## Library Construction Concerns – 4/2/2022

At the March 21, 2022 Library Board meeting, project manager Doug Landry presented the Board with a disc containing the 100% completed construction documents for the new library. The disc documents are in review by Parish Government, the Permits Department, Community Development, and the Fire Marshall. Mr. Landry suggested the Library Board review the documents also. The Library staff also reviewed the documents. The following document highlights several areas that require reconsideration and correction to avoid costly change orders after the bid is advertised and construction begins.

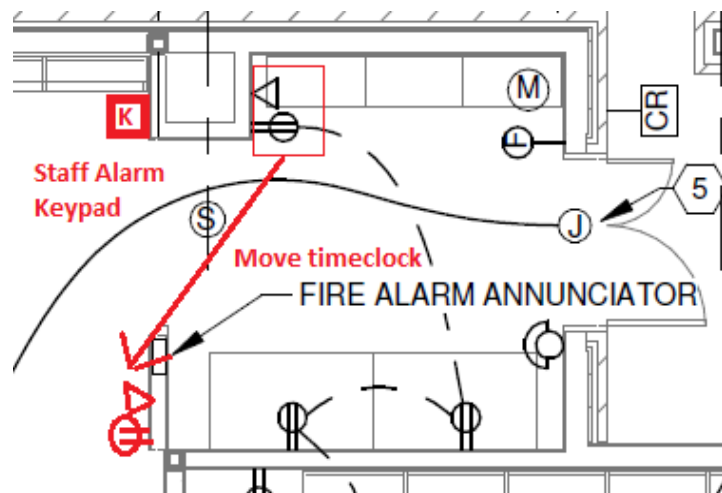
1. **No power outlets for “hot backup” computers.** Hot backup computers are ones that can be unplugged from storage and used immediately....they need to be online to receive nightly windows updates. While there are Ethernet data jacks shown, there are no outlets to power them. This storage area should support at least 8 computers (hopefully 12). Please add the duplex outlets and Ethernet jacks indicated (*shown in red*) to the plan.

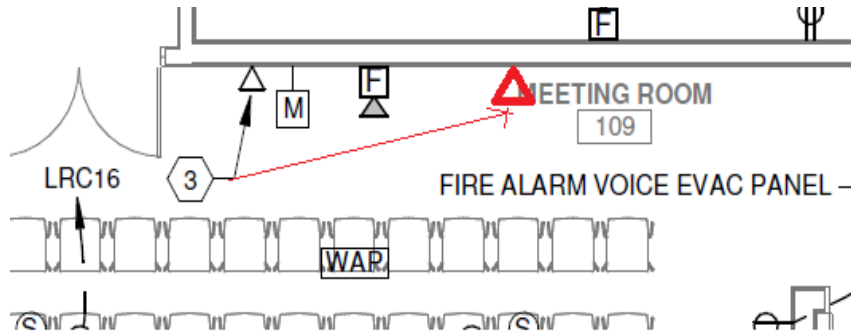
2. **Staff entry/exit changes.** While there is a keypad at the main front patron entrance to arm/disarm the security system, the staff will probably not use it, since they enter and exit in the rear. Please add an additional alarm keypad as indicated. Also, the outlet and Ethernet jack drawn for the employee time clock should probably be moved as indicated so that it is visible upon exit, and to make room for the in/out rack of ID cards without a table blocking the way.

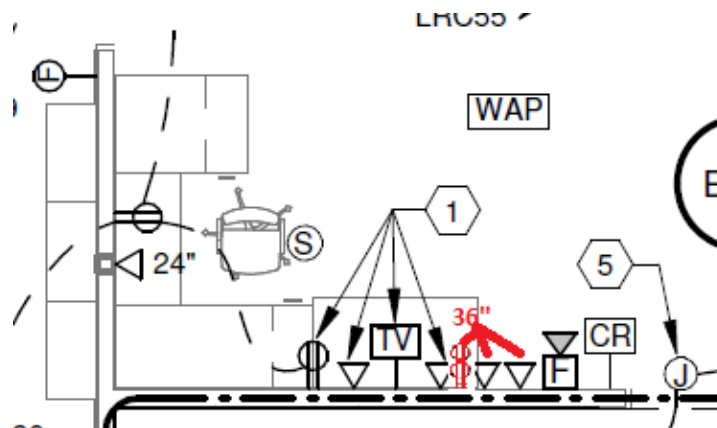
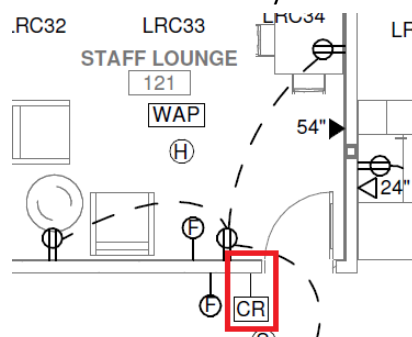
**3. Public meeting room needs an additional IP camera jack.** Most of the action occurs at the front stage area. Sometimes the presenter moves, and sometimes you need to vary between wide and close-up shots... or a guest walks up to the area with the presenter. All of this can't be covered with just one camera in the back. Please install another Ethernet jack 1 foot from the ceiling as indicated.

**3. No outlets for Dwight's repair workbench.** The plans show an outlet for the TV above the workbench for monitoring of security cameras by the staff, but there is no outlet at the workbench table for Dwight to plug in a computer or other device being repaired, or any tools like a soldering iron. Please add two duplex outlets indicated at tabletop level. Also, the Ethernet jacks need to be above counter level as well (except for the one used by TV, which needs to be 3 feet or so down from the ceiling).

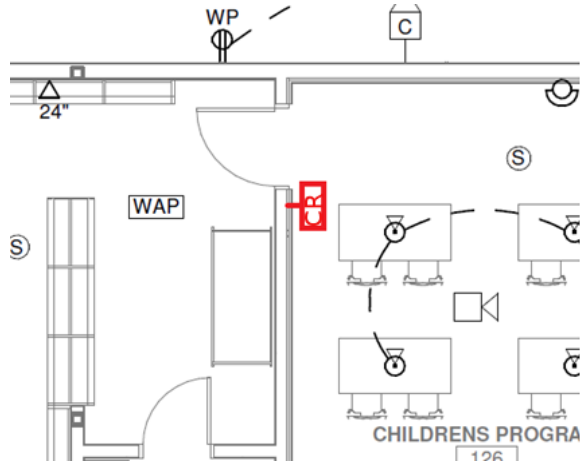
**4. Remove staff lounge card reader.** The kitchen area is a low-security area and does not need restricted access from the public because it already is located in the staff area. Please remove it.

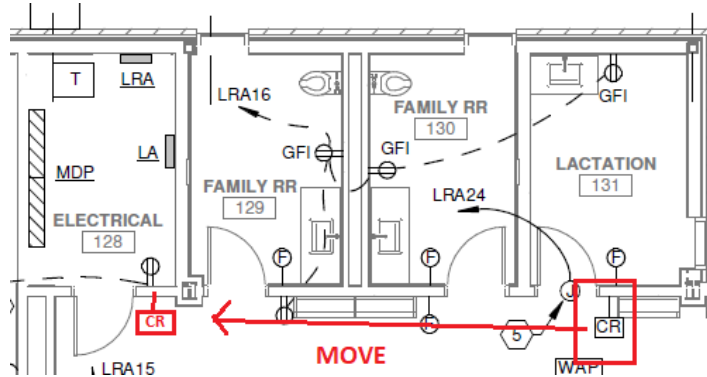
5. **ADD a card reader to Children’s Program/Storage area door.** The public, especially children, should NOT be attempting to get into the staff area from the story time area. Please add a card reader to secure this door.

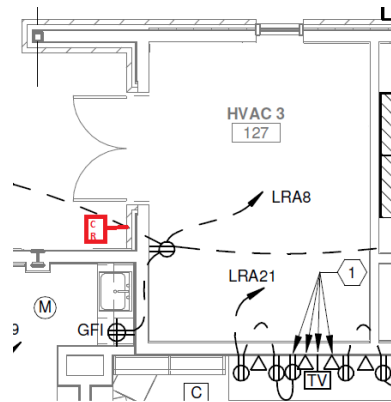
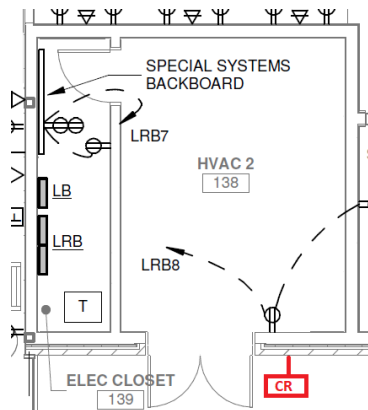
6. **Card reader misplaced on plans.** The public lactation room should NOT be locked, but the plans show an access card reader. Conversely, the electrical closet does NOT show a card reader and has to be secured from the public. Please move the card reader to the proper location.

7. **ADD card readers for HVAC and electrical rooms.** Please add these security devices to the equipment rooms to secure them.

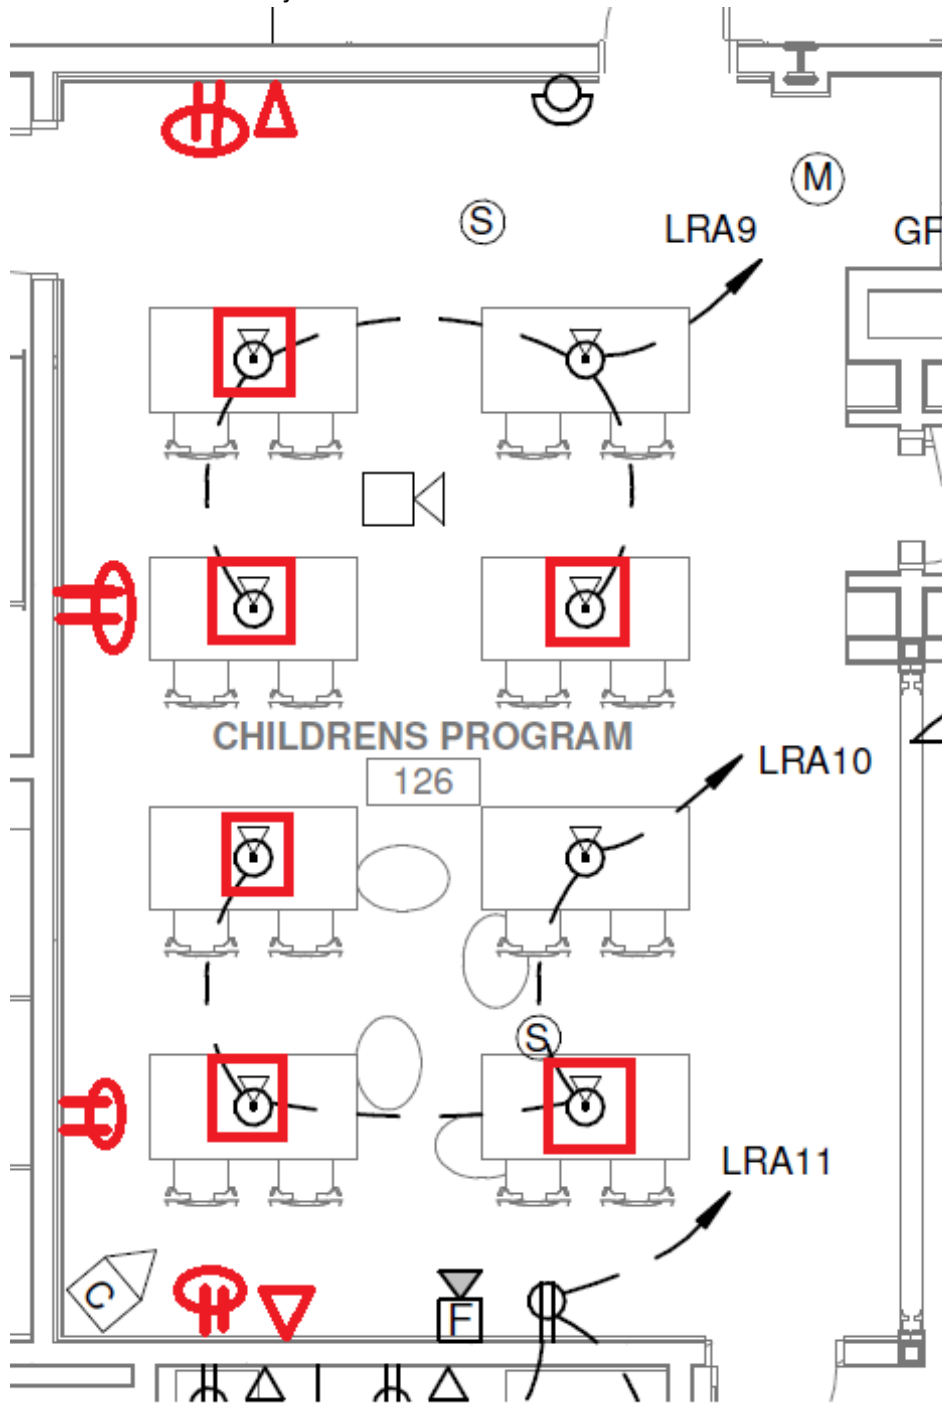
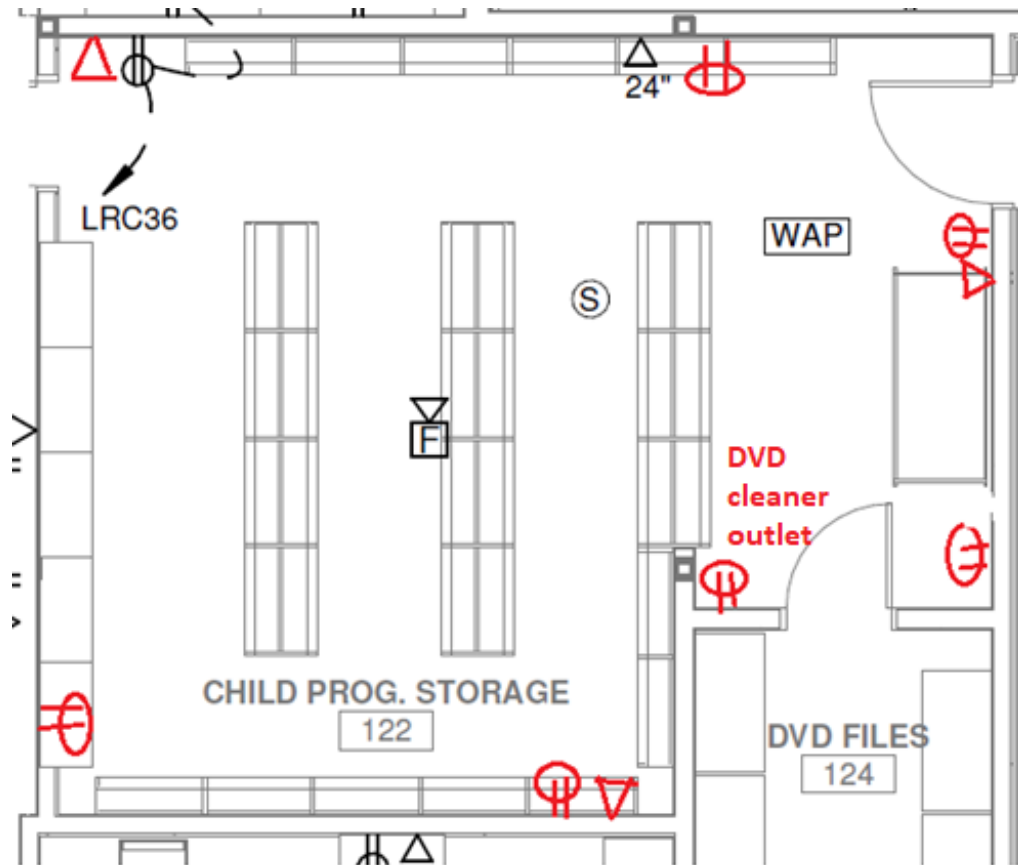
8. **Children's Program Area outlets.** There is no need for so many Ethernet floor jacks and power outlets for each craft table in the room. It is NOT SAFE for young children to be using electrical items like glue guns, nor will they be using computers as a classroom in this story time area. There may be a future need to install a computer, game, or other device, so keeping a couple of floor outlets would be wise. In addition, the presenter/storyteller may also need to plug in items either at the front or back of the classroom. Please remove the floor and Ethernet outlets circled and install wall outlets and jacks as indicated.

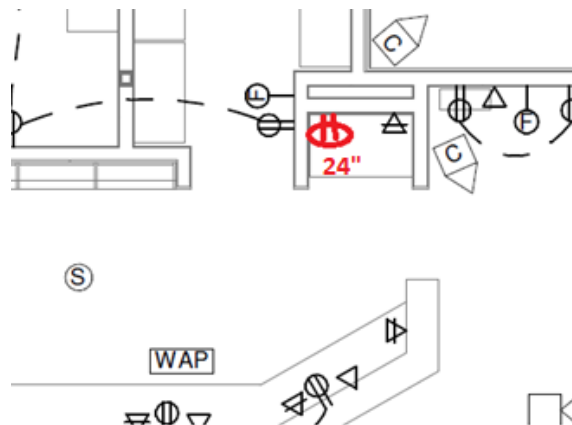
9. **Child program storage room changes.** While we envision using this room primarily for storage, there is a possibility that it might be used as an auxiliary staff work area in the future. We also have a DVD cleaning machine that needs power. Future staff support devices may also need power. Please add the following Ethernet and power receptacles shown.

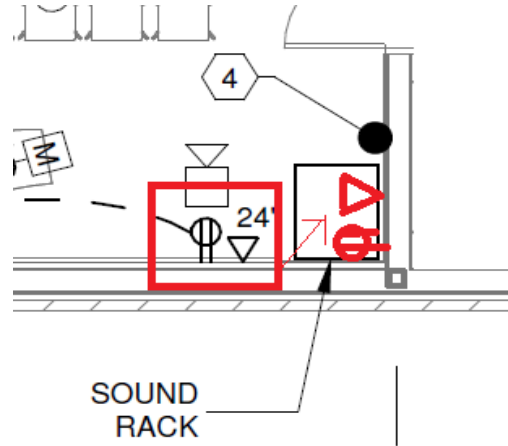
10. **Circulation work table needs power.** We currently plan on using the table to house the FAX machine, but the table needs to have power to operate. Please add this outlet, preferably above counter height.

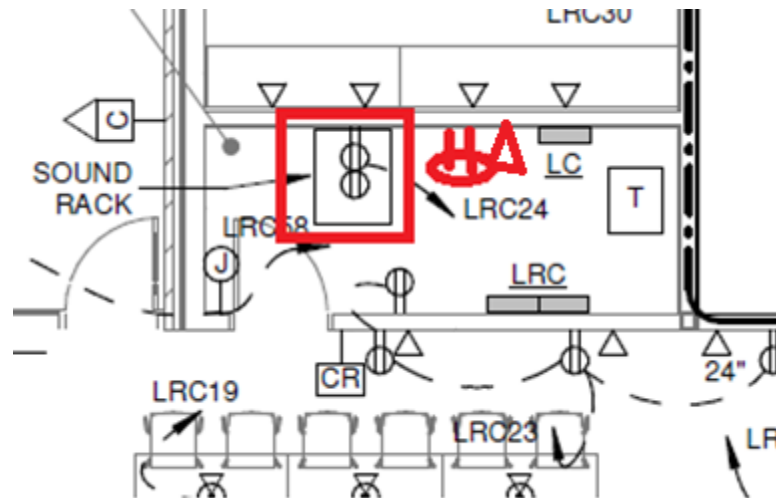
11. **Move outlets closer to audio/video equipment rack.** The wires should be hidden as much as possible in the corner of the main meeting room. Please move the Ethernet and power outlet as indicated. Also, there should be a cabinet built or purchased for this rack secured by a lockable door, due to the cost of the equipment (*amplifiers, Blu-Ray players, etc.*) in the rack.

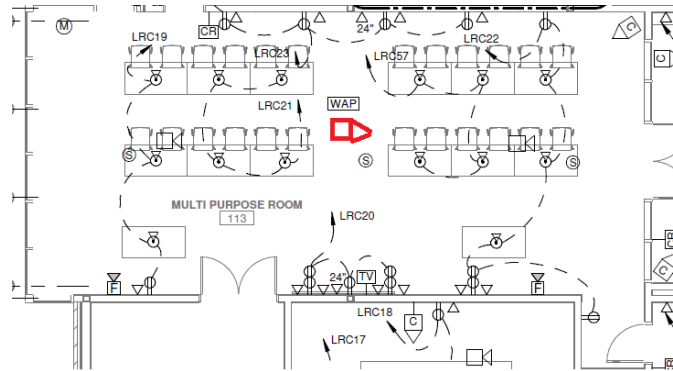
12. **Remove extra sound rack.** The sound rack located in the electrical closet next to the multi-purpose room (room 114) was initially there to control sound for the main meeting room. Now that the rack has moved into the corner of the meeting room itself, the rack here is no longer needed. Please replace the double duplex outlet with a single duplex outlet and an Ethernet jack, in case there is a need for another device in the future.

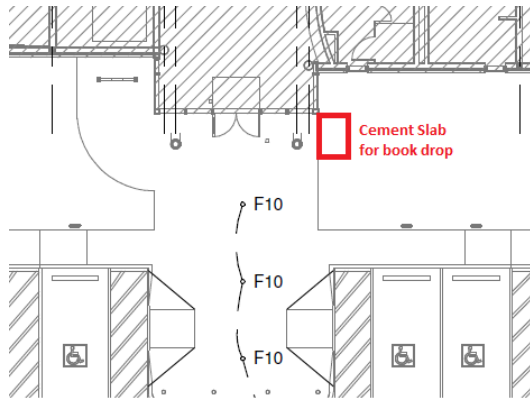
13. **Multi-purpose room missing a PA speaker.** The main meeting rooms, the conference room, and all of the group study rooms have a ceiling PA speaker to hear library announcements. The multi-purpose room also needs one, because it will be very hard to hear if the doors have been closed to the main library.

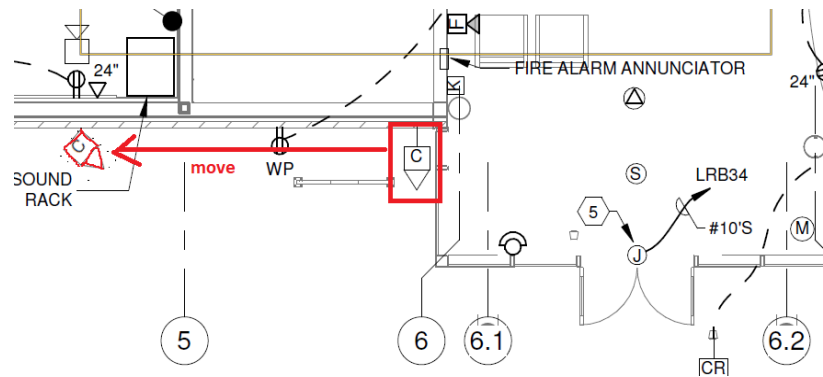
14. **Book return cement slab.** Please pour a 7 foot long by 5 foot wide slab near the front entrance so that an after-hours outdoor book return can be bolted into it as indicated at the front entrance.

15. **Front security camera position change.** The existing location of the outside camera by the front door is too close to the side wall, which obstructs a lot of its view. Please move the camera and angle it as indicated to get a better view of people entering the building and the bike rack area.

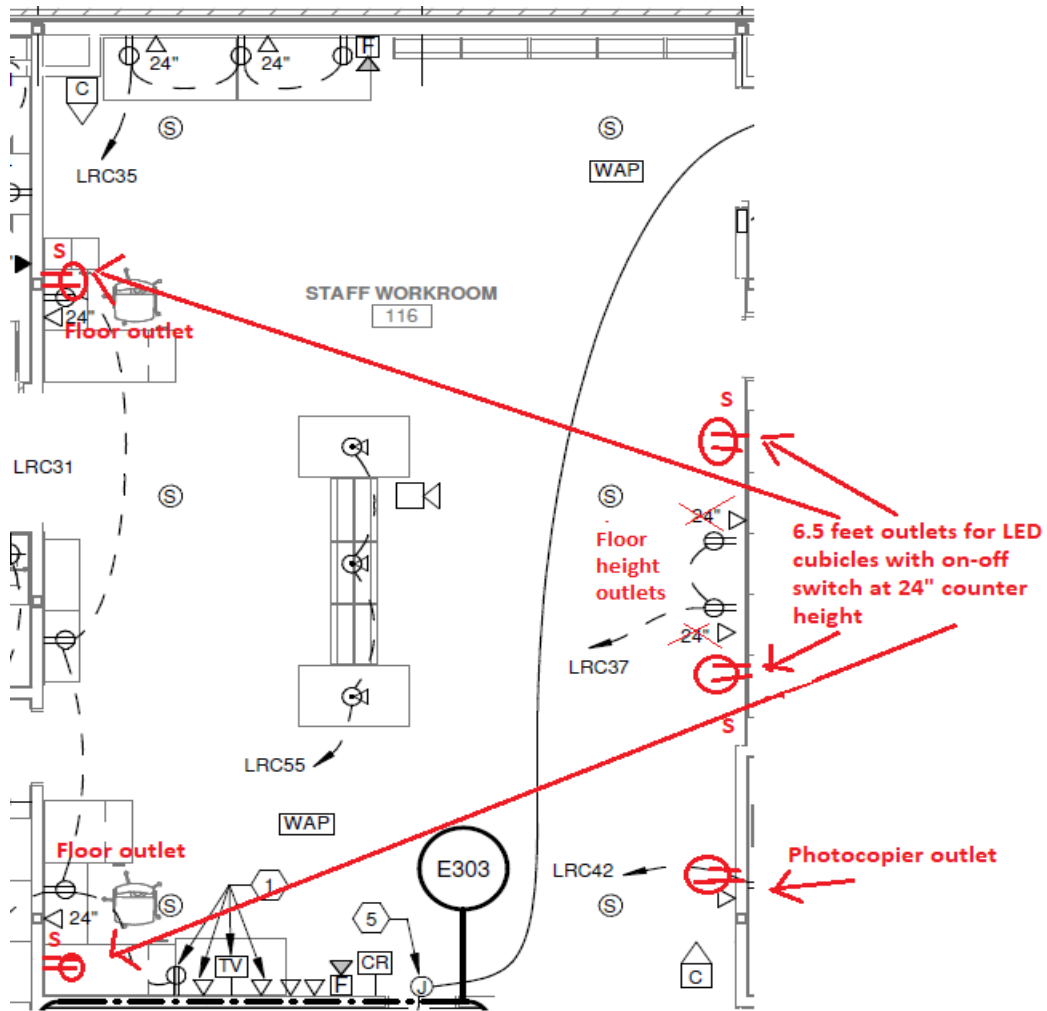
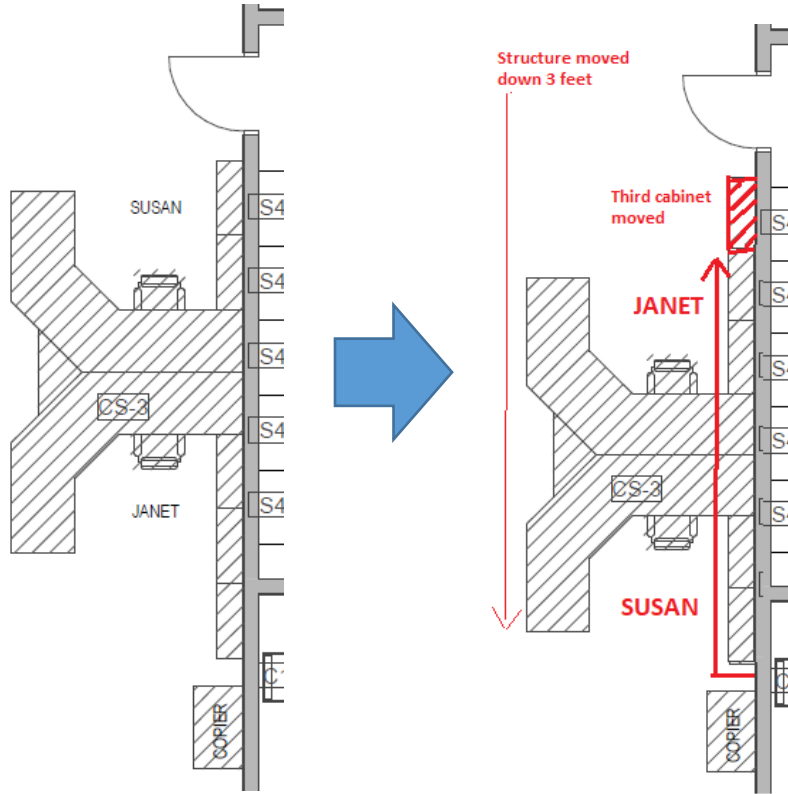
16. **Staff cubicle power outlet changes, and photocopier.** Our existing cubicles have LED lights both inside and under the overhead cabinets that are controlled by an outlet at the 6 ½ foot level above the cabinets, and controlled at each cubicle with a light switch. Where the 24" outlets are listed, a switch needs to be added for the outlet to turn on these lights. Since the computers used by these cubicles are at floor level, the existing electrical outlets shown need to be at normal level for these computers. We asked for an Ethernet jack near the entrance for a photocopier which was indicated in the plans, but there was no outlet to power this device. Please add this outlet.

Light switch above countertop in staff cubicle

Power outlet above staff cubicle cabinet

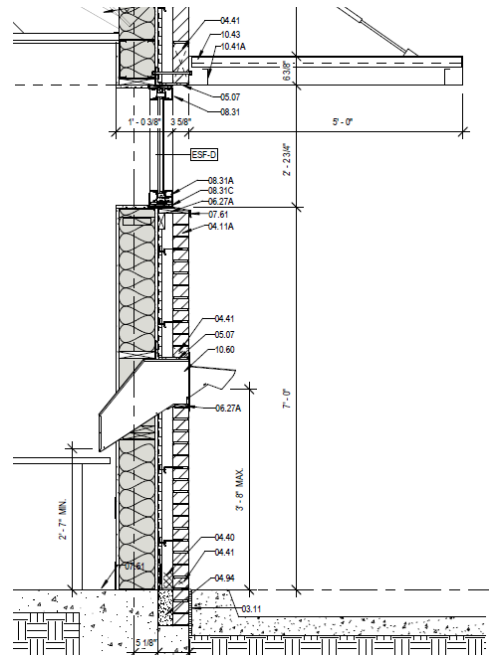
17. **Staff Cubicles wrong.** The plan has Janet and Susan's cubicles in the wrong location. Janet is the Children's librarian and needs to have her desk next to the Children's storage closet door and path to the children's area. She uses 3 side cabinets and Susan uses 2 cabinets. Please slide the desk/cubicle structures down approximately 3 feet and move one cabinet to fix this error.

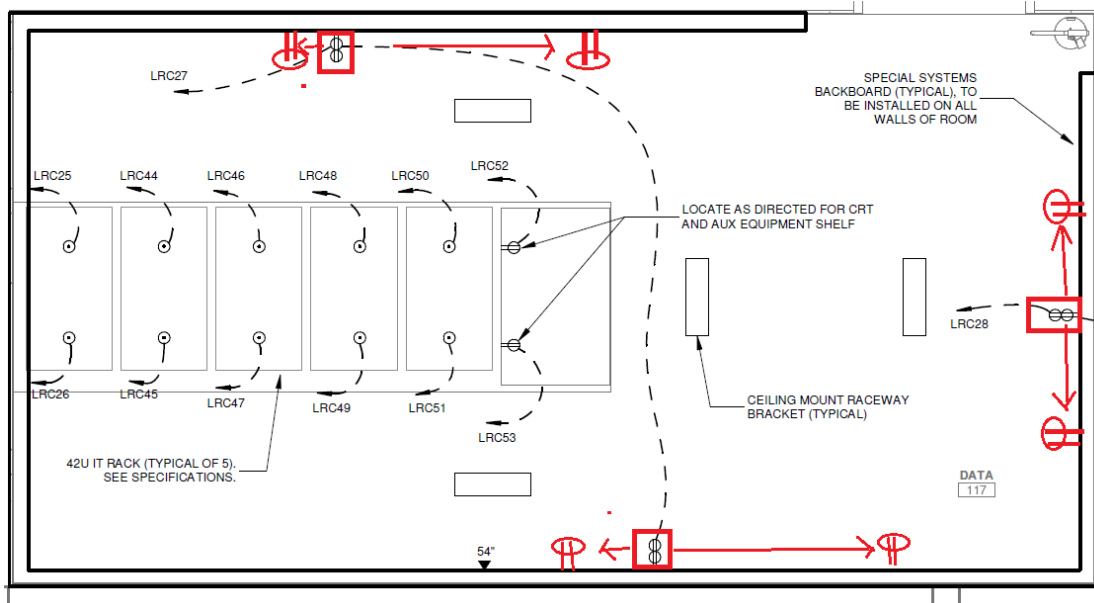
18. **Remove outdoor book slot and awning.** Page A414 shows an outdoor drive-up book slot in the back of the library. From past experience at the old library, this is an insurance hazard which increases our premium. The public has placed trash, fireworks, snakes and other materials in the slot after hours, which damaged the other books and items inside the library. Please remove this feature from the plans.

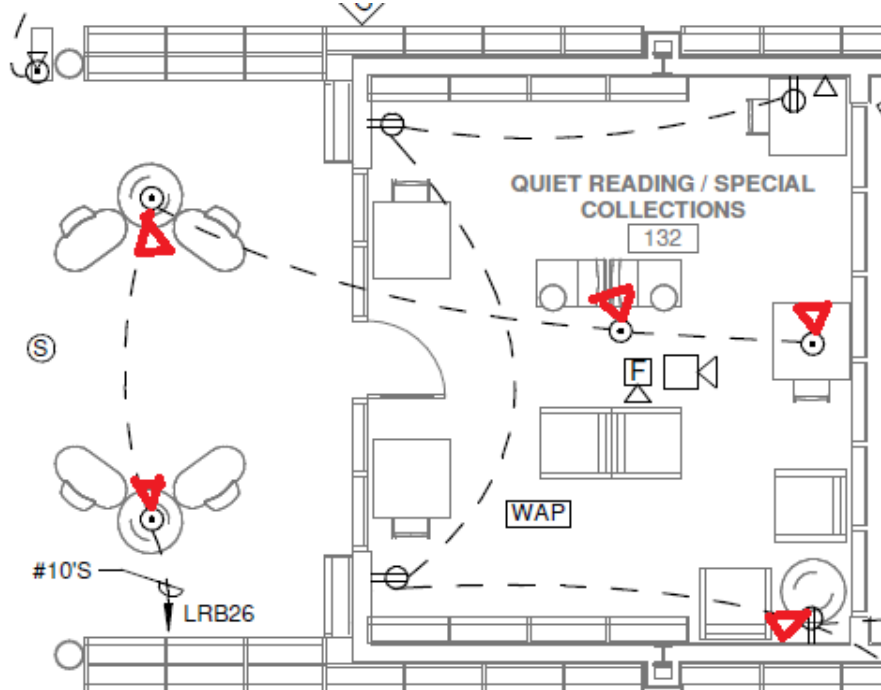
19. **Move and separate data room power outlets.** The existing plans call for two duplex outlets in several locations. This will cause a bottleneck of devices bolted to the wall at each location. Also, if the vendor devices have a “power brick” on the plug, other nearby outlets will be blocked, rendering them useless. Please move and separate the outlets as indicated.
